GREEN STEEL – RESPONSE TO CORRECTIONS

The proposed Green Steel metal recycling plant at 61 Hampton Downs Road, Hampton Downs (the Proposal) was lodged for consent under the Fast Track process. As a neighbour, the Springfield Correctional Facility (Springhill) has had the Assessment of Noise and Vibration Effects (ANVE) I undertook reviewed by Styles Group. These resulting comments are provided by the Consulting Advice Note (CAN) Styles Group prepared, dated 20 May 2025. As requested, I have responded to the queries raised in the CAN.

Figure 1. Site Plan Showing Proposed Bund

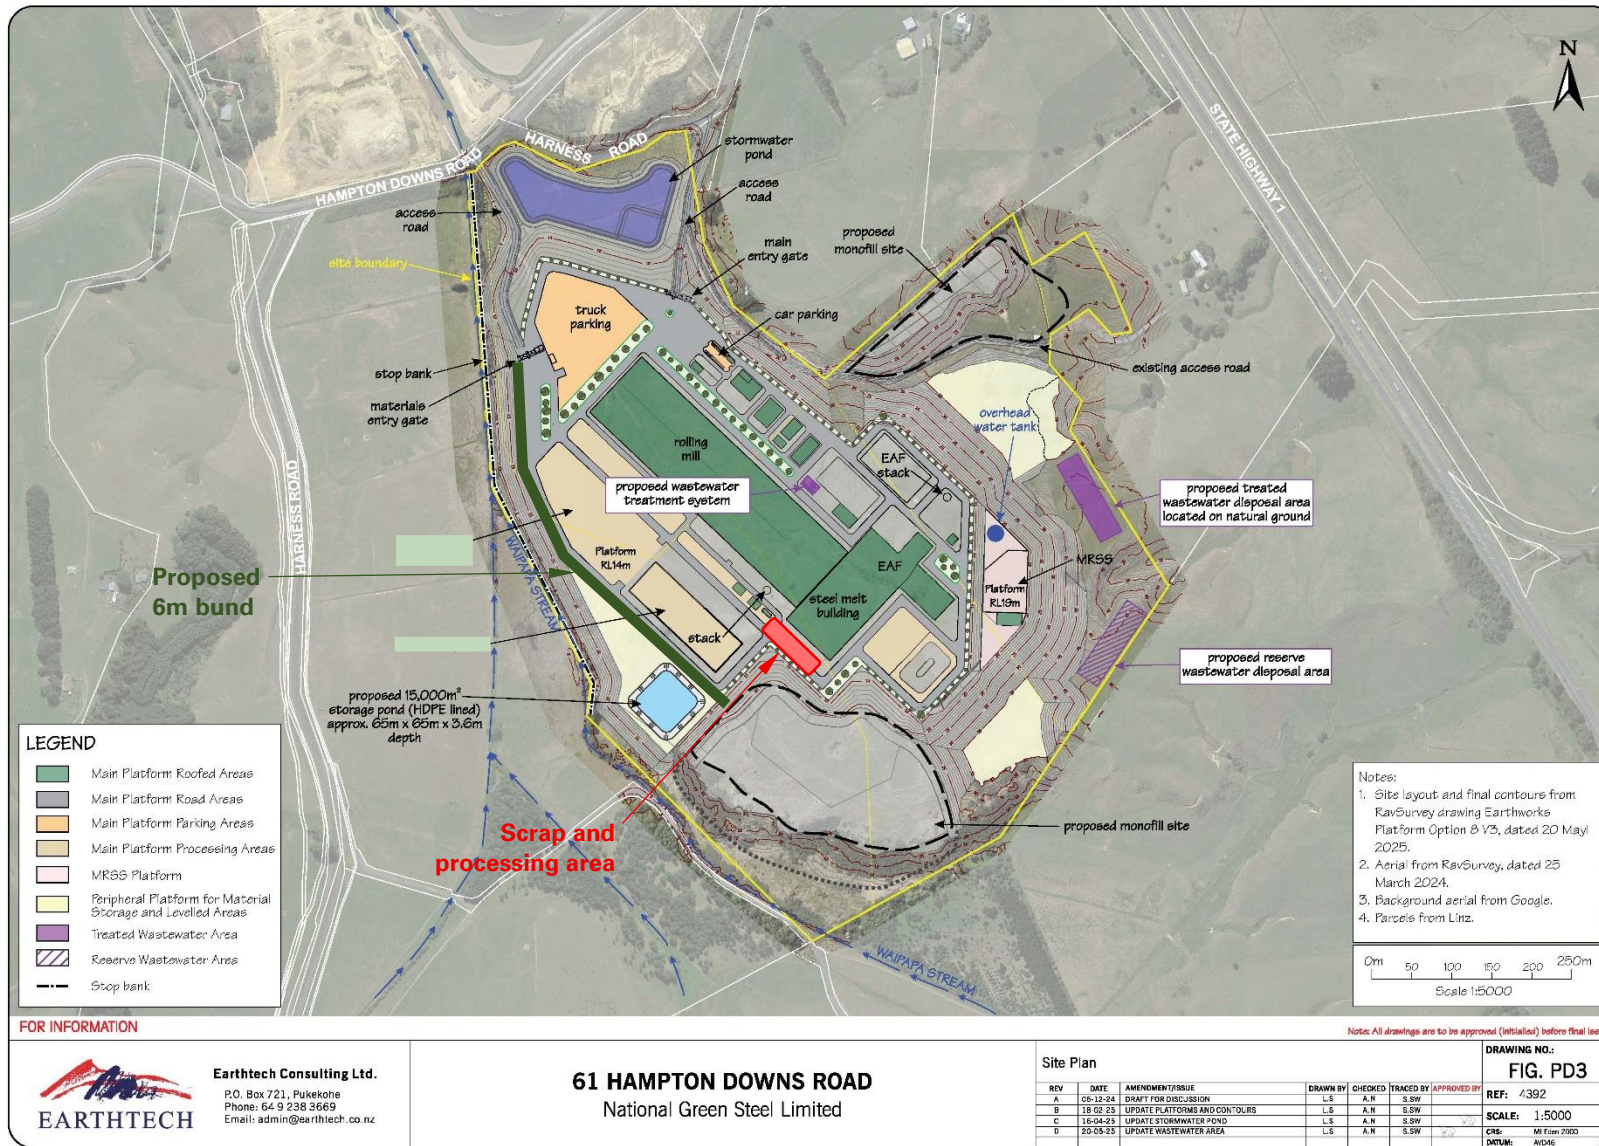
The Springhill site extends the full length of the western boundary of the Proposal before continuing to the south of the Proposal. The existing prison buildings are located to the south of the Proposal with the only apparent activity to the west being the prison access road. Figure 10 of the ANVEv2 shows this. In considering potential effects on Springhill, the ANVEv2 was premised on the wording of the Springhill designation that appears to limit future development to the southwest of the existing buildings on site. It is noted that the Corrections Special Purpose zone of the WDP refers to residential accommodation being located in accordance with approved designation plan RC03 Revision 3. However, Council has no record of this plan and was not able to provide it. Corrections have also not provided this plan. My interpretation is that the designation appears to exclude future accommodation on the portion of the Springhill land immediately to the west of the Green Steel Site.

Nonetheless, the design team made the decision to provide mitigation to the currently vacant Corrections land immediately to the west of the Proposal. This has been achieved through the addition of a 6m bund along the length of the Proposal's western edge of the working area, as shown in Figure 1. This height was selected as it ties in with a cut at the southern end of the site. Further, investigations into increasing the bund height showed little return on additional height. For example, increasing the bund to 8m high resulted in no more than an additional 2dB reduction to the Springhill land. Typically, a 3dB change in level is considered the smallest that the average person can detect.

Further, the scrap area and shredder have been moved southwards, to nestle into the back of the cutting to the rear of the site.

Figure 2. Day Time Noise Contours

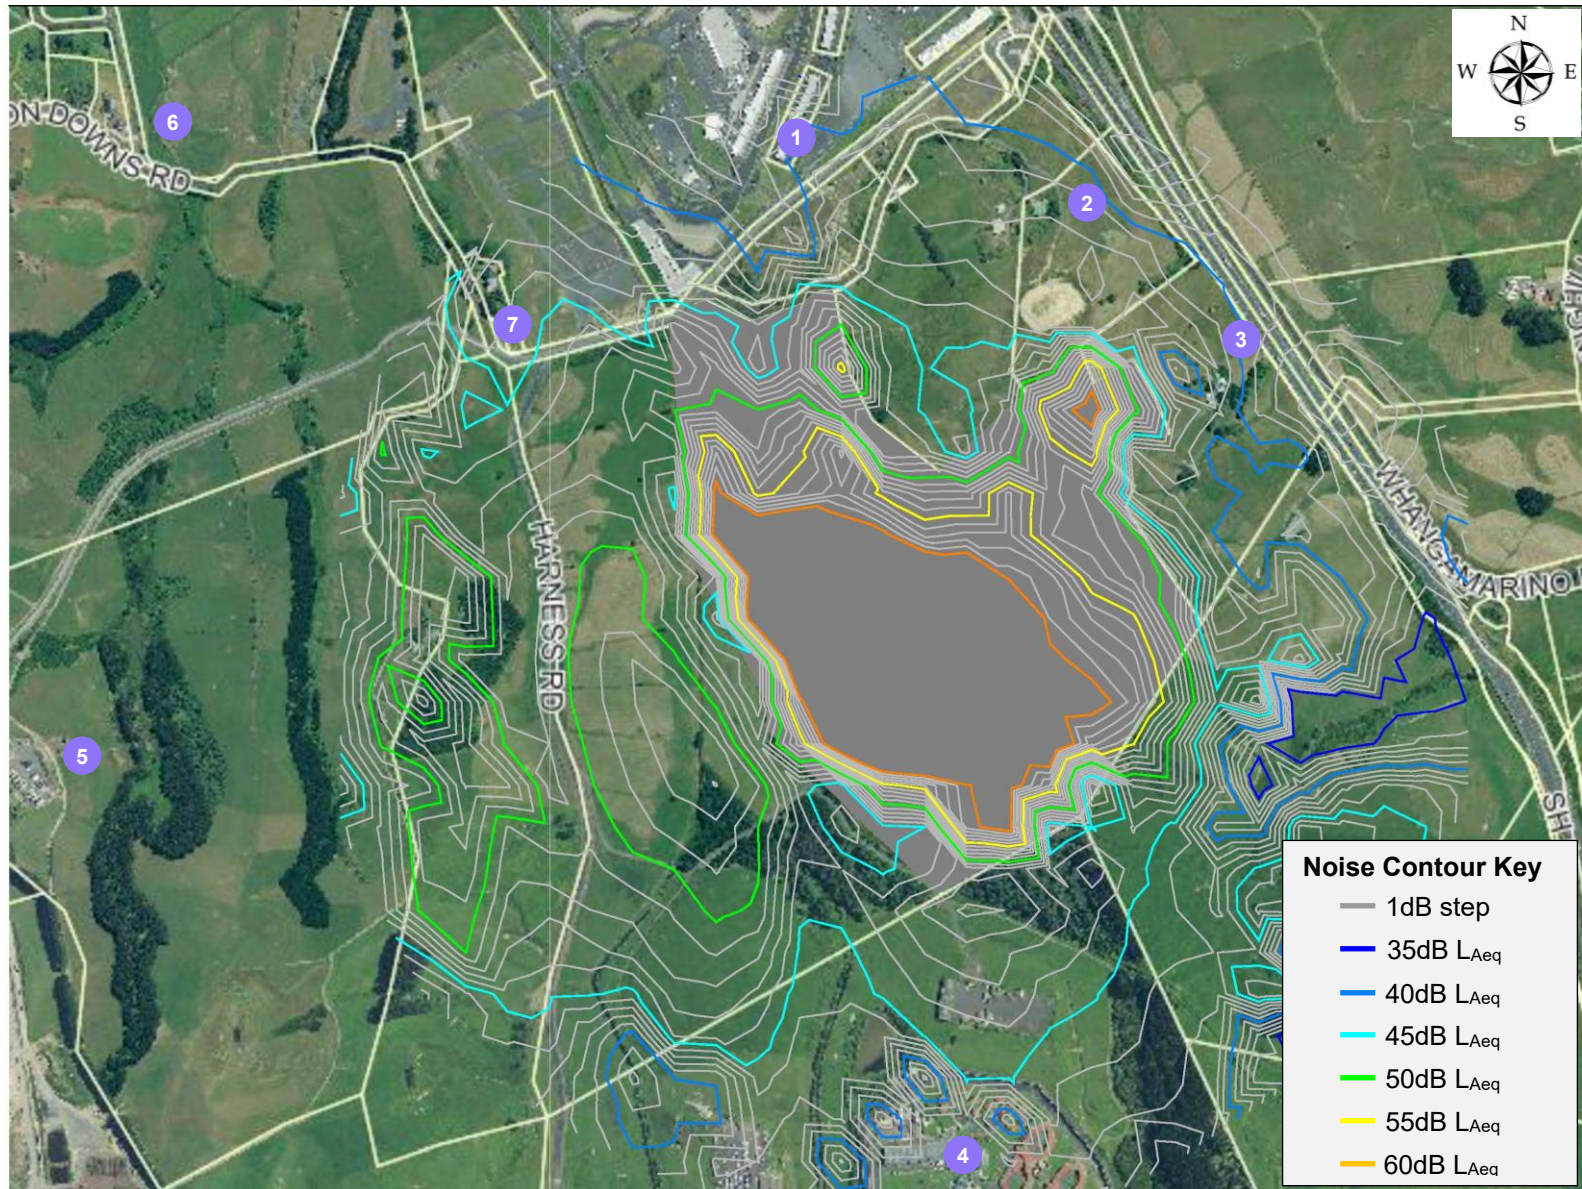
The approach taken by the ANVE was to assess the effects on the existing dwellings. The CAN makes the point that, being within the rural zone, there is some potential for additional development of these sites. On their review of the ANVE, Council raised the same query, which I responded to by producing contour plots of the proposed noise levels (Figures 5 – 7 of the updated ANVE (ANVEv2)) with a discussion on the results in section 4.8.

The following Figures 2 and 3 represent the day, and the evening/night time contours from the Proposal respectively with the inclusion of the western bund. These Figures replace the similar Figures 5 – 7 of the ANVEv2.

Figures 2 and 3 show that over the corrections land to the west, the proposed 6m barrier will significantly reduce noise levels from the proposal. Specifically,

- a. Figure 2 shows noise levels will be up to 53dB L_{Aeq} during the day time. The proposed bund will reduce noise levels in the order of 5dB;
- b. Figure 3 shows that, during the night time, levels will be up to 42dB L_{Aeq} . The proposed bund will reduce noise levels in the order of 3dB.

Figure 4. Spectral Analysis of MP2 Measurement (Springhill)

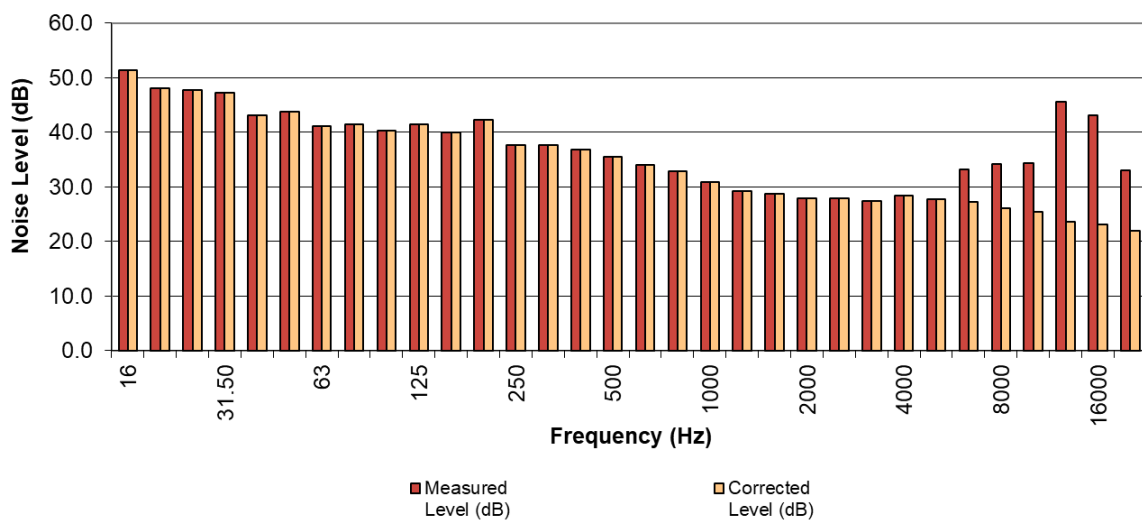
The ANVE includes measurements of the existing ambient sound as part of the assessment of the noise effects. The CAN notes their view that, based on measurements they have undertaken for a different site, noise from cicadas and crickets would have controlled or significantly influenced the overall noise levels.

When crickets and cicadas are present, they can be identified by spectral analysis of a noise measurement as both result in increased levels of high frequency noise. The logging equipment used for the Proposal did not have the ability to undertake such spectral analysis, which is typical of equipment used to remotely log sound. Instead, handheld measurements were undertaken of the ambient sound for 15 minutes when the loggers were first installed and again when they were picked up. For each logging location, both the before and after measurements confirmed the site observations that the influence of insect noise was minimal. To demonstrate this, the following Figure shows a spectral analysis of the ambient sound measurement adjacent to Springhill (MP2). The effects of cicadas can be observed by the increase in levels above 6,300Hz. When corrected manually, which is also shown in the Figure, the cicadas were found to contribute 3dB to the overall level. This is a relatively small contribution and, for that reason, was not specifically included in the assessment. If it were, the conclusions of section 4.6 of the ANVE would remain unchanged.

Based on the above, I consider that the ambient sound measurements presented in the ANVE are appropriate to use and that the conclusion drawn from them remains valid.
